# Briefing of Wanda Line Phase I Public Art Commission - Q&As

March 29, 2022

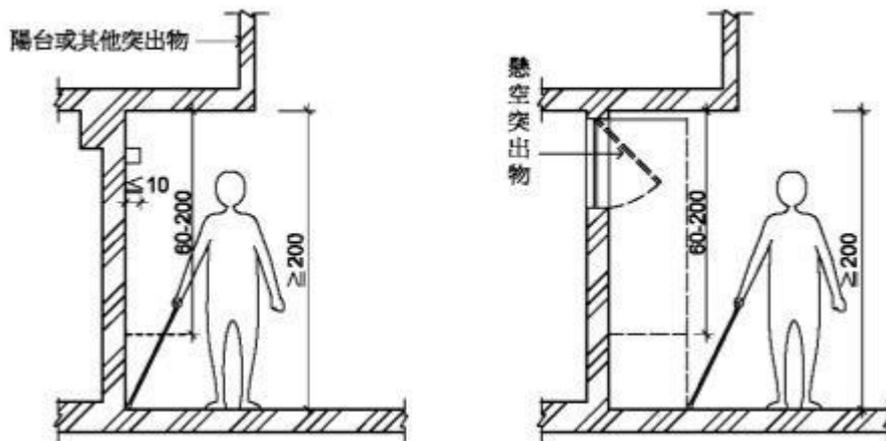
2. What is the requested size of design drawings?

**Ans:** A mock drawing of the life-size can be produced first for reviewing members to realize the scale of the artwork to a real person. In the future, when it comes to contract signing and on-site installation, a detailed size specification and the size scale to the surrounding space are required.
